DS #: 4615

PROJECT: NORTH CREEK (PREVIOUSLY SABLE CREEK)
(PROJECT IN CLARK COUNTY FOR CLV CONCURRENCE)

CITY OF LAS VEGAS		DATE:
INTER-OFFICE MEMORANDUM		July 16, 2014
TO: Land Development Services Department of Building and Safety		FROM: Albert Sung, P.E. Flood Control Project Engineer Department of Public Works
SUBJECT: Drainage Study for: North Creek (Previously a portion of Sable Creek) (Project in Clark County for CLV Concurrence)		COPIES TO: Slater Hanifan Group
Cross Streets:	SWC of Farm & Grand Canyon	Lennar Homes
File Number:	F:\Depot\DSMemos\DS4615D.doc	Bart Anderson, P.E., DevCo
Parcel Number:	125-18-301-025	Doug Rankin, Planning
Zoning Action:	ANX-49991	
FEMA Flood Zone	YES NO X	
Proposed Storm Drain	YES X NO

UPDATE No.4 TO THE TECHNICAL DRAINAGE STUDY

PP-6
SHEET 13 OF 30

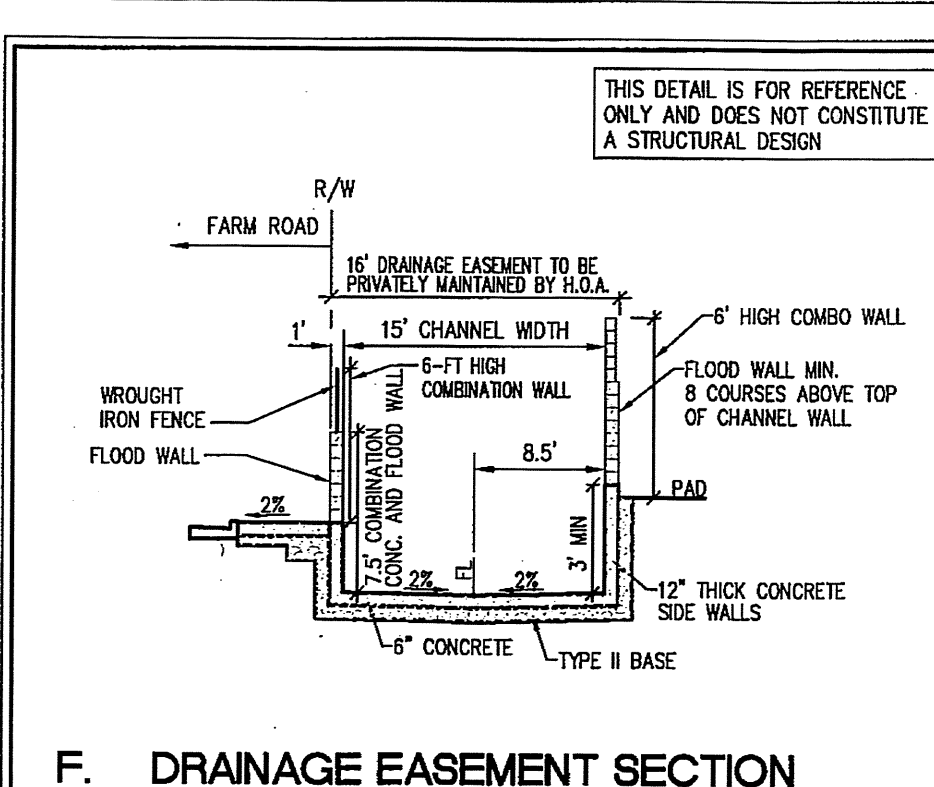
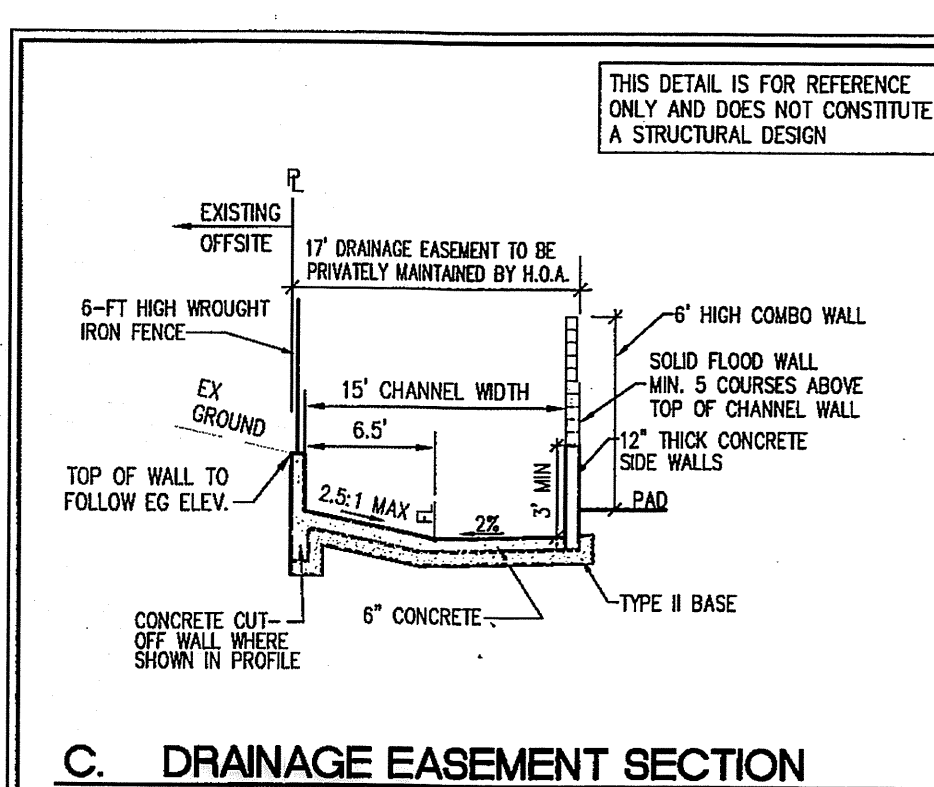
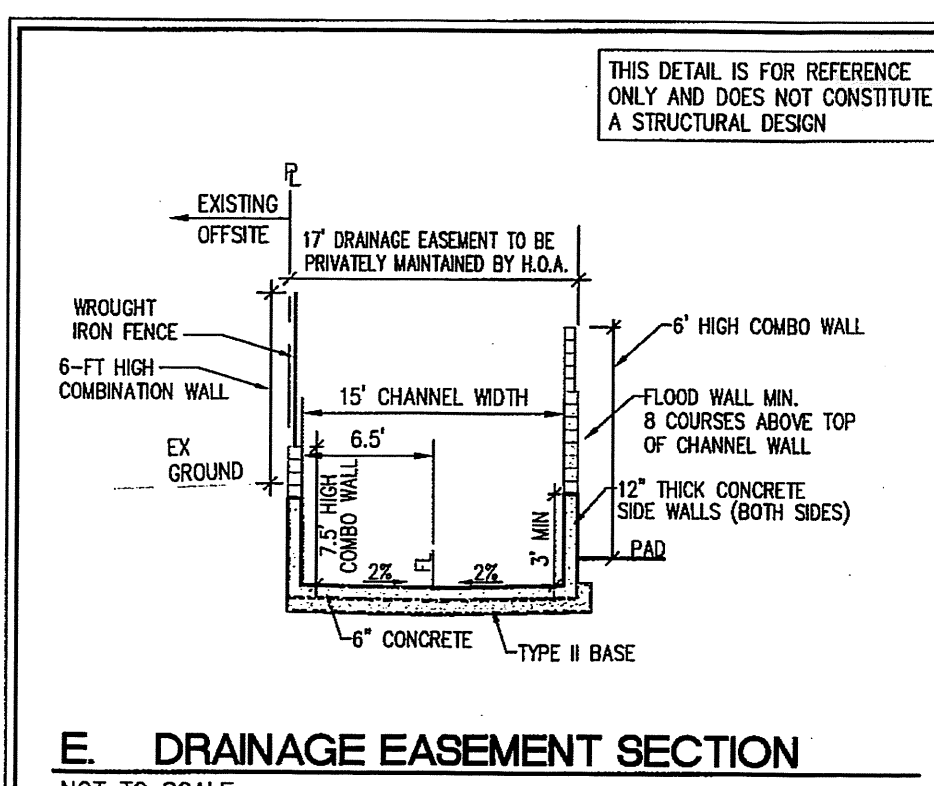
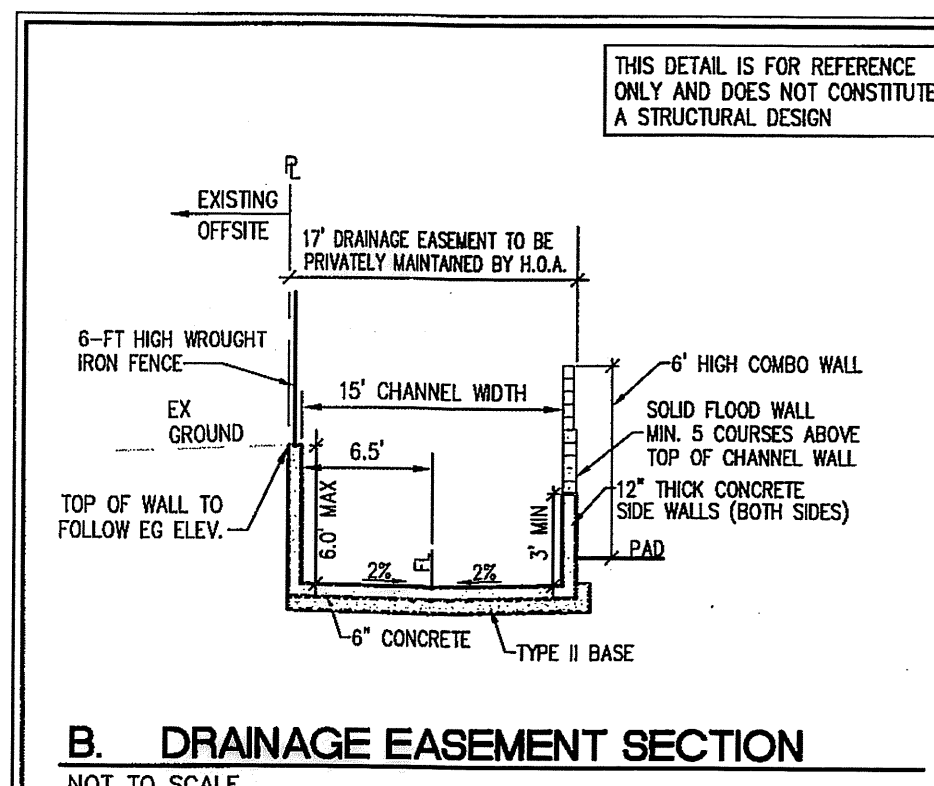
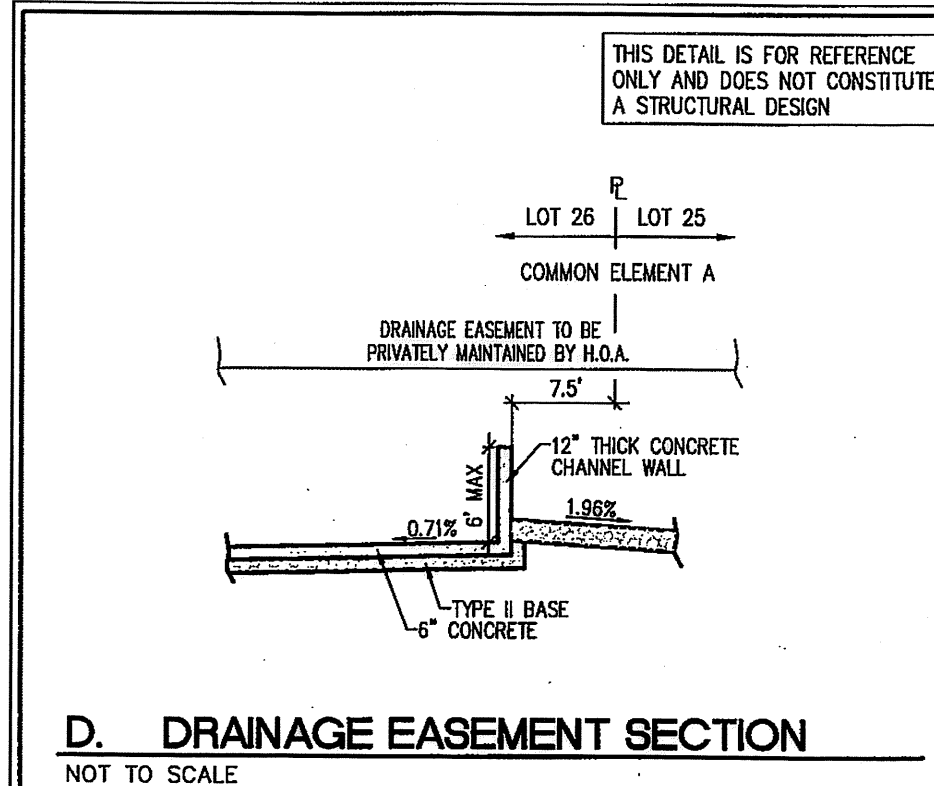
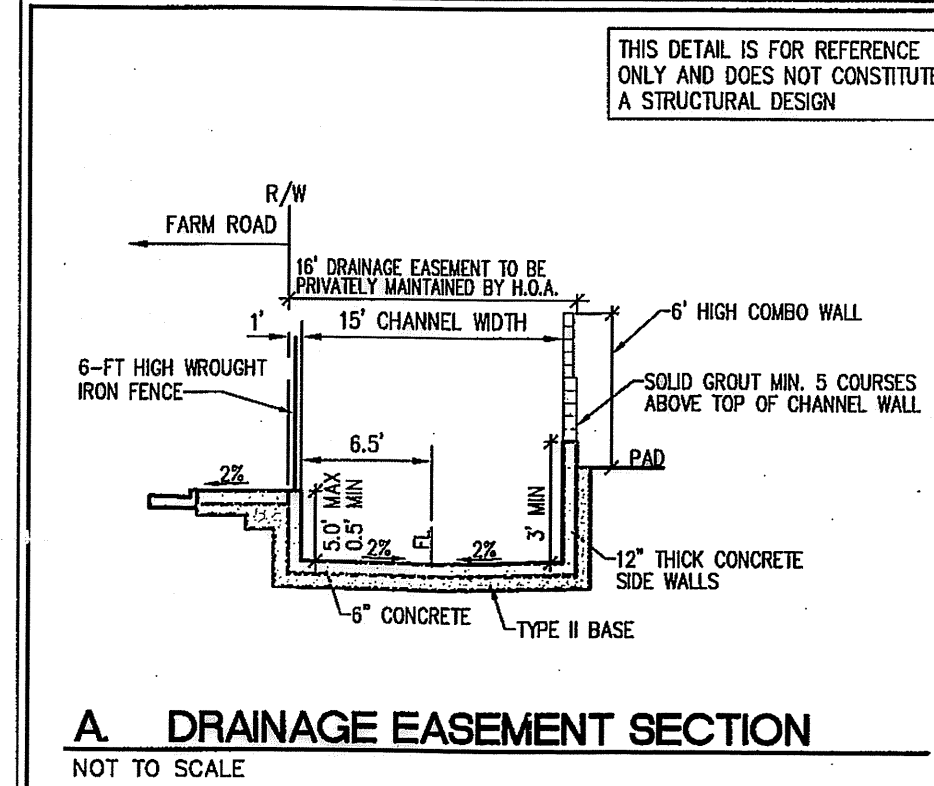
1. The flood wall details shown on Sheet PP-6 have been revised. The revised flood walls are approved based upon the reduced flow impacting the site. Add a note to the plans *"Flood Wall to be a minimum 8-inch CMU, solid grouted."*
A copy of the approved Flood Wall design needs to be submitted to Flood Control.
2. Coordinate the Streetscape Improvements along Farm Road and Grand Canyon Drive with the Planning Department. The 5-foot landscape amenity zone is conceptually approved using stamped concrete with tree wells provided at intervals acceptable to the Planning Department based upon the tree sizes provided. Provide details for the stamped concrete that include the pattern, thickness, base material and tree wells.

Changes to Channel Design: The reduction in flow rate has allowed for a reduction in the height of the flood wall height above the concrete channel per the above discussion. Refer to the revised Sheet PP-6, included in Appendix F, for profiles and details for the Farm collector channel.
